**JNRA2022-0005  
PSP2023-0008  
Revision #3  
Received 11/29/2023**

**Site Plan Review**  
Reviewed for compliance with City Ordinance, Building and Fire Codes  
Conditions and mark-ups noted throughout plan set must be addressed prior to final approval

project  
**Oakland Gospel Halls**  
 1590 Walton Blvd.  
 Rochester Hills, MI 48309

# SITE PLAN.pdf Markup Summary

**CITY CONSTRUCTION DETAILS**

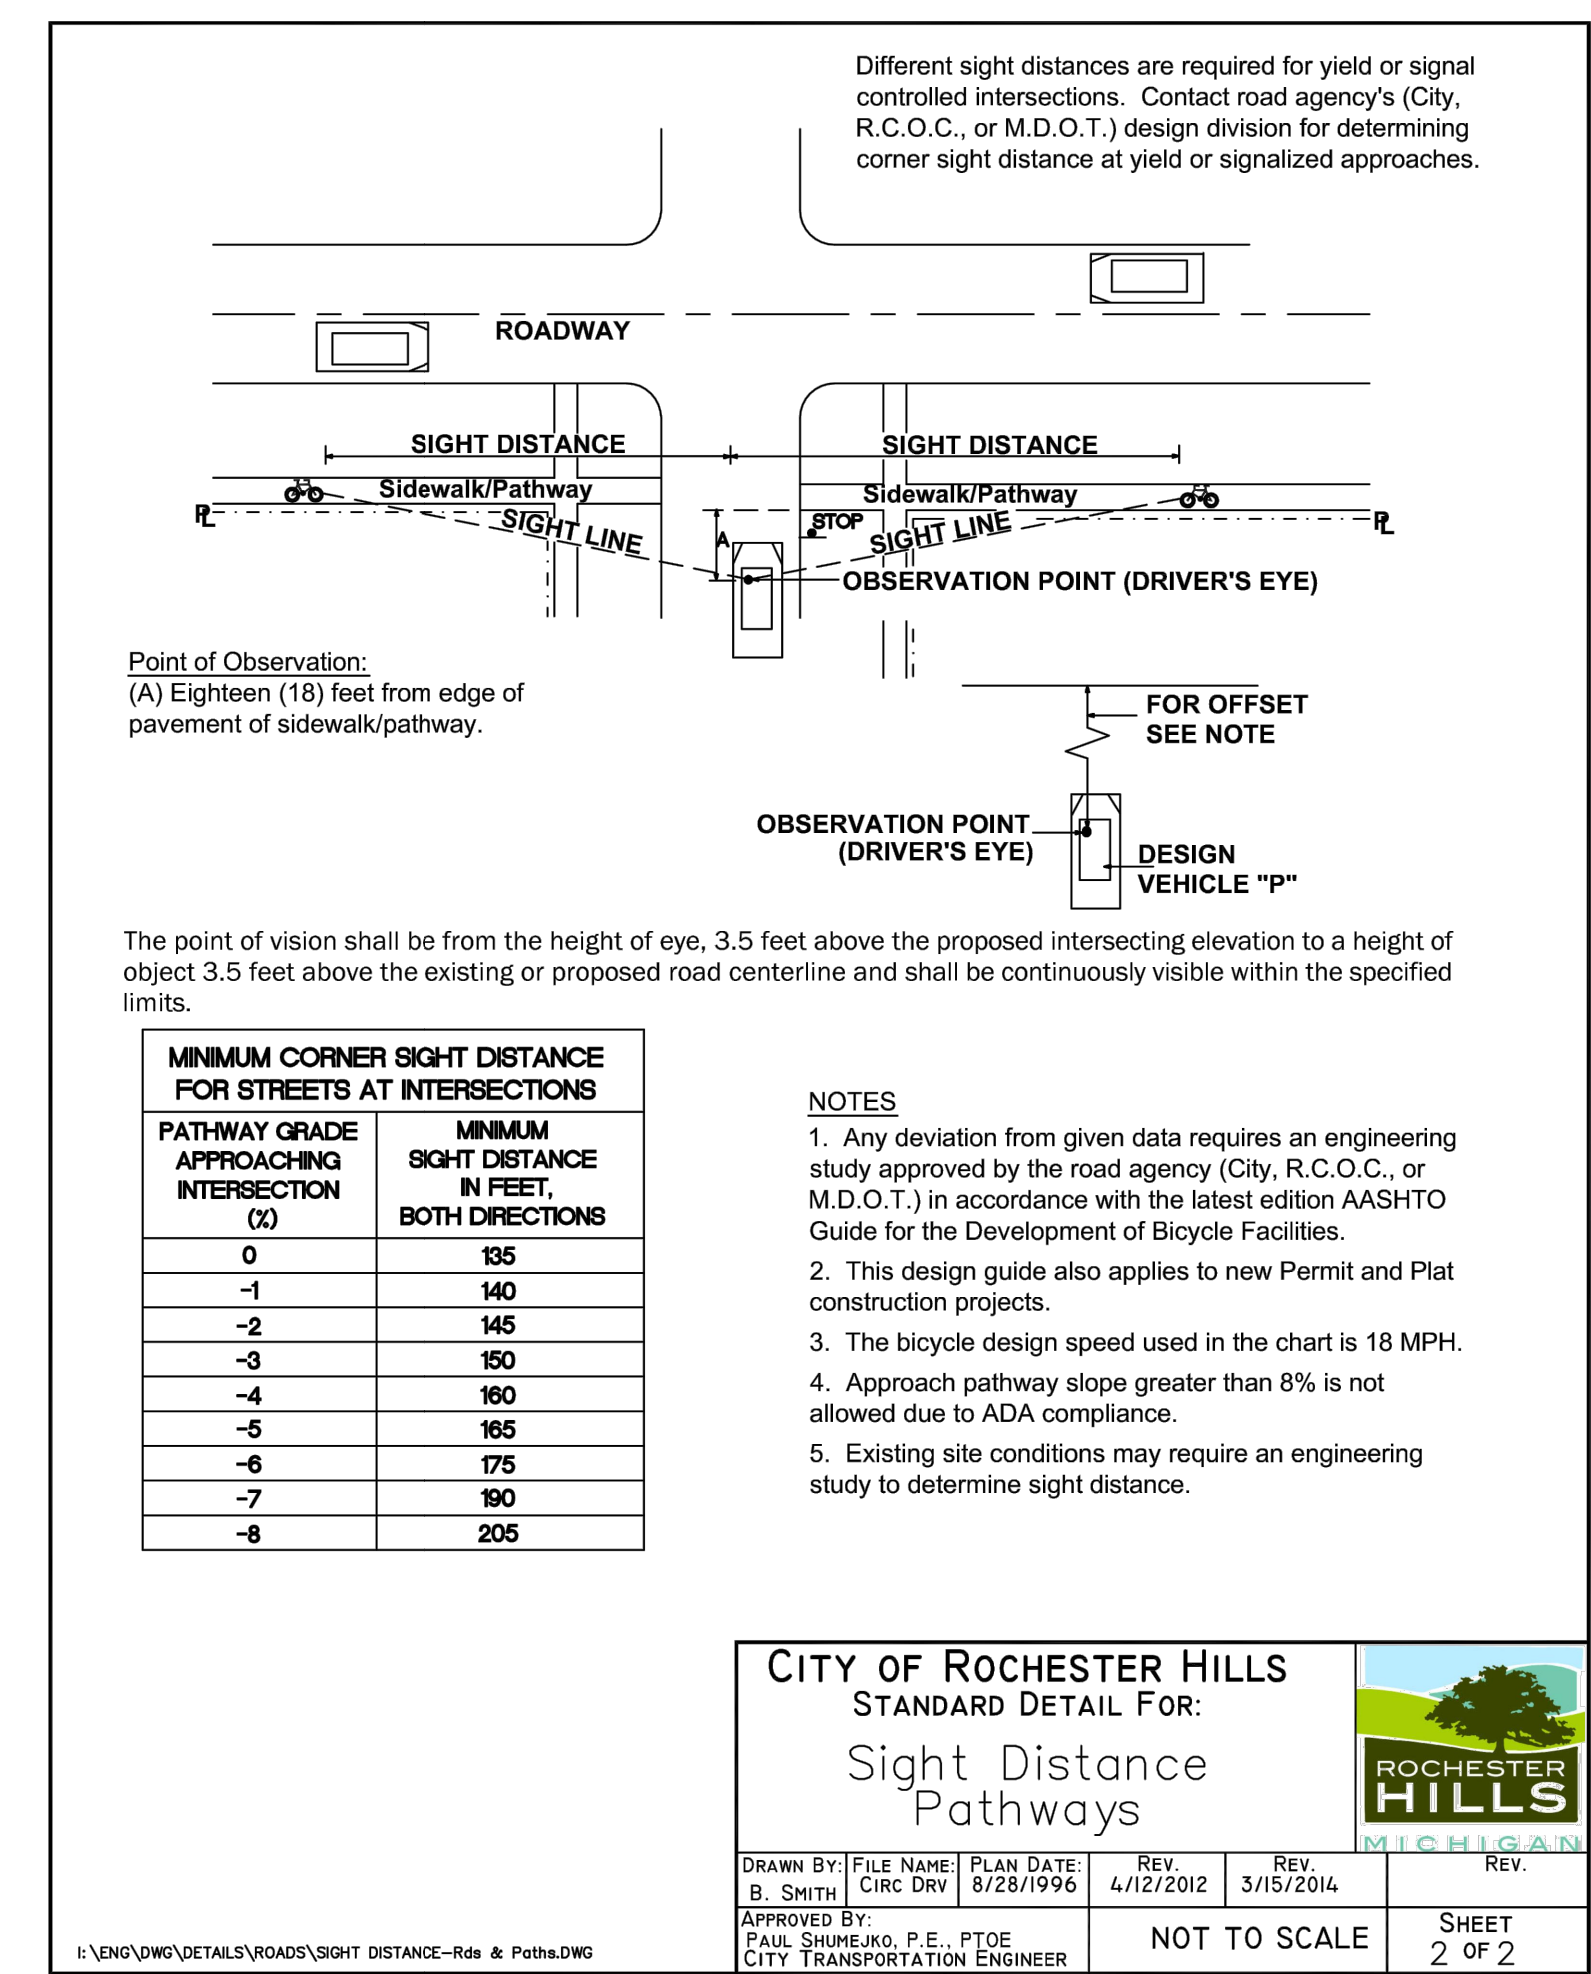
include updated(R-28-K dated 11.8.23) and all plan sheets. See attached within BS&A.
